SPRINGDALE SOLAR FARM

Further Request for Information (RFI) Report

Author Steven Reid
Date 1st October 2020
Ref 04317-1602908

2.1 RFI & proponent response

CONSTRAINTS AND LAYOUT PLAN - FINAL

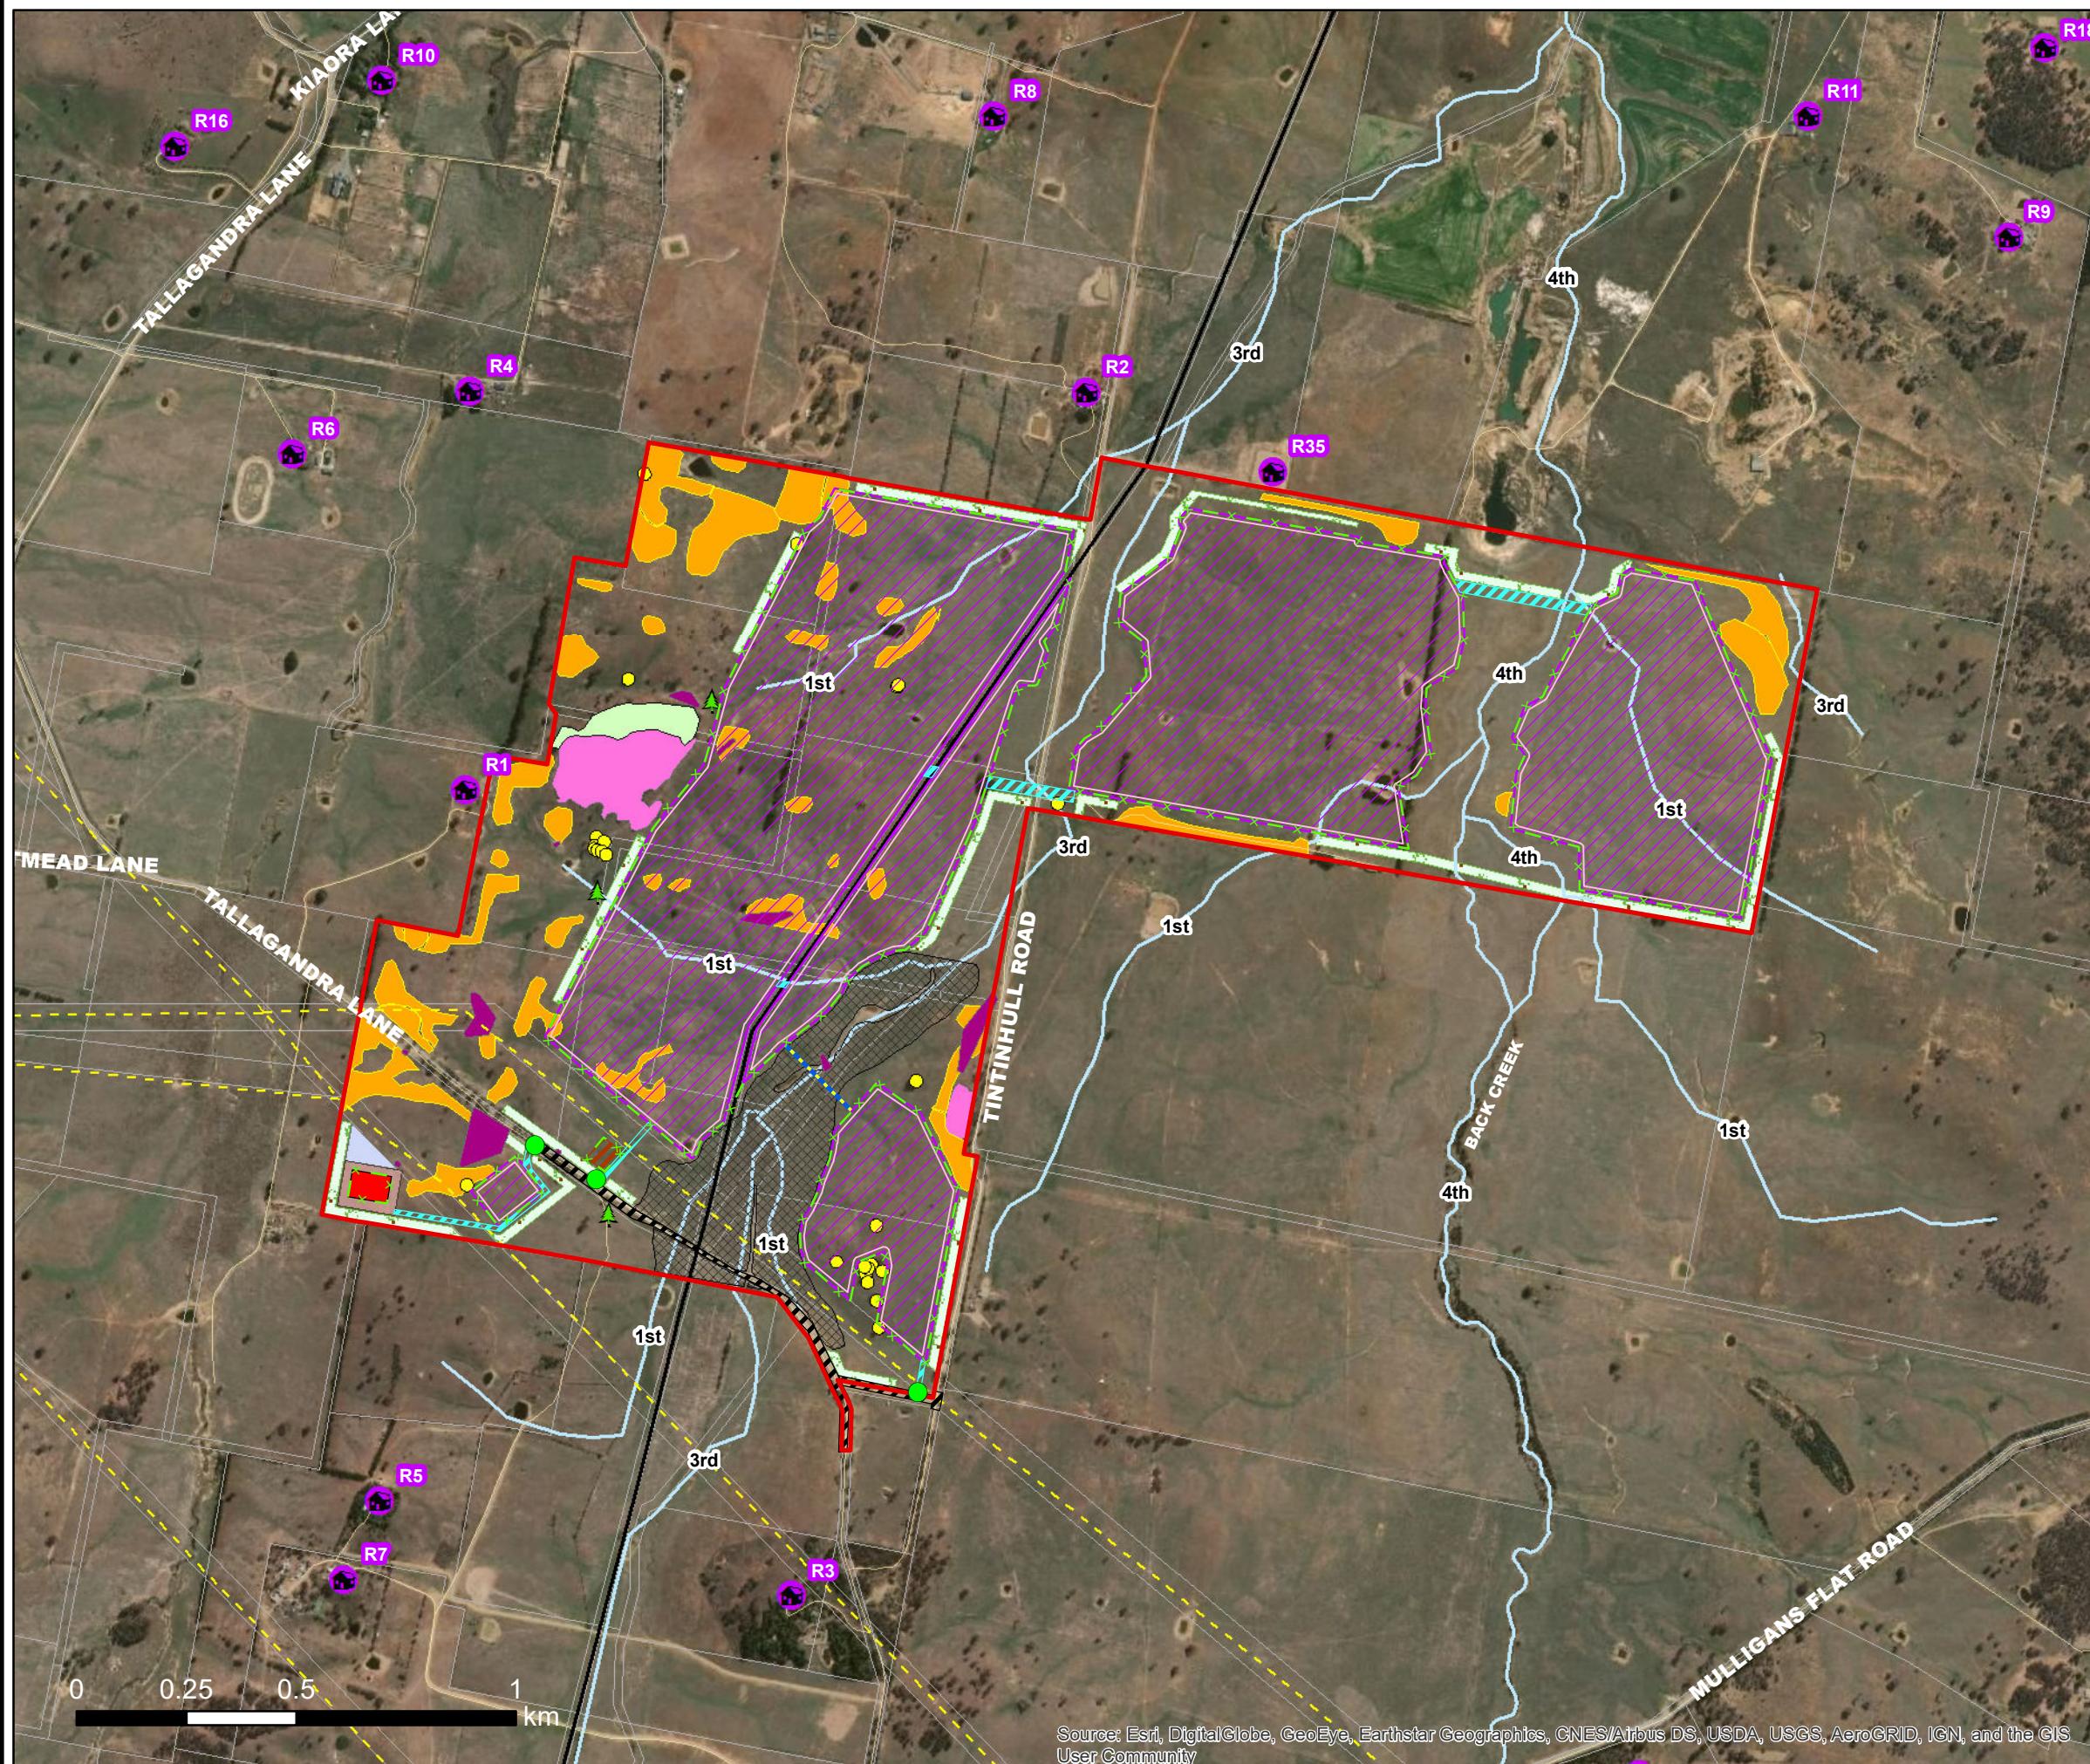
Confirm how the SE array section would connect to the substation;	The SE array will utilise directional drilling or an OHL avoiding the SLL habitat. This has been updated on the final layout plan at Annexure C.
Confirm the size of the final development footprint;	Final development footprint, including Development Area, tracks, control room and substation is 185Ha. The current optimised layout is based upon 257,634 modules. This is an approximation and the final detailed design will confirm the number of panels to be used.
Clarify traffic movements of OMOD, heavy and light vehicles during construction, and heavy and light vehicles during operation. Noting that a traffic movement is considered entering and exiting; and	The EIS states the following: Construction: 75 daily heavy vehicle movements, 400 daily light vehicle movements and approximately 16 oversized vehicles. It also notes these numbers are based on a single vehicle movement either entering or exiting the site. Considering this, we continue to support the proposed heavy vehicle and light vehicle numbers for the construction period. Converted to the anticipated definition of 1 vehicle movement equating to the vehicle entering and existing site. The numbers would be defined as; 38 daily heavy vehicles movements and 200 daily light vehicle movements. We consider the oversized vehicle movements to be overstated and would propose a change to 3 oversized vehicle movements during construction. Operations: 10 daily light vehicles movements during the first 2 years. Water trucks will be required for panel cleaning when there is less rainfall. This could equate to between 2-3 water trucks per week over the course of a year.

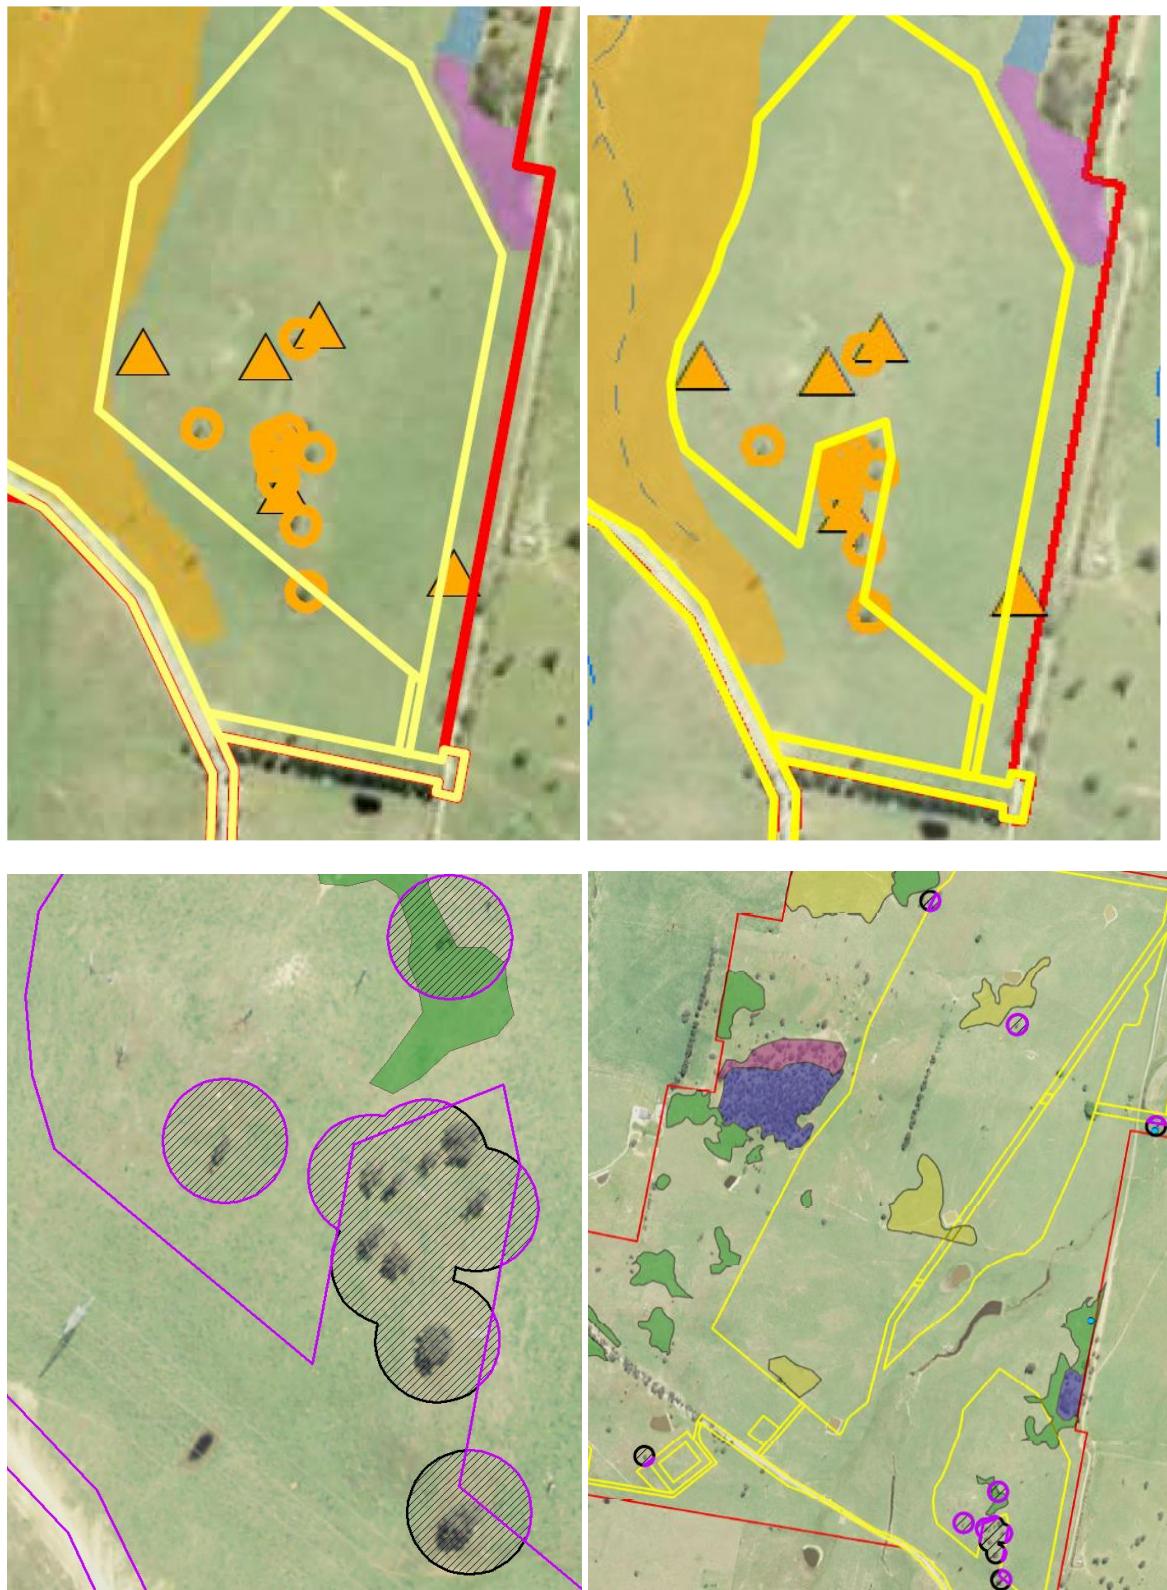
*There is a stand of hollow bearing *Eucalyptus mannifera* (Brittle gum) in the south-east corner of the site, adjacent to Tintinhull Road, as shown in Figure 6 of the BDAR. This area is suitable Superb parrot breeding habitat and should be avoided or offset using the Biodiversity Assessment Method. If the trees are retained, the BMP should include actions to protect them in the long term such as excluding grazing to promote tree regeneration.*

The OEH submission (2018) noted that *E. mannifera* had been proven to be a candidate breeding tree for Superb Parrot and that the *stand of hollow bearing Eucalyptus mannifera (Brittle gum) in the south-east corner of the site, adjacent to Tintinhull Road, as shown in Figure 6 of the BDAR*) should be avoided due to potential breeding habitat or offset (see Plate 1).

In response, the design footprint was amended to avoid the referred-to trees, as stated within the updated BDAR (June 2020), and the offset of 0.25 ha was maintained for impacts to remaining trees within the development area. The BCD reviewed the amended design (June 2020 correspondence) and sought additional protection or offsetting for trees to be cleared or that are adjacent to the development footprint.

Based on these changes the Superb Parrot species polygon has been revised from 0.25 ha to 0.94 ha.
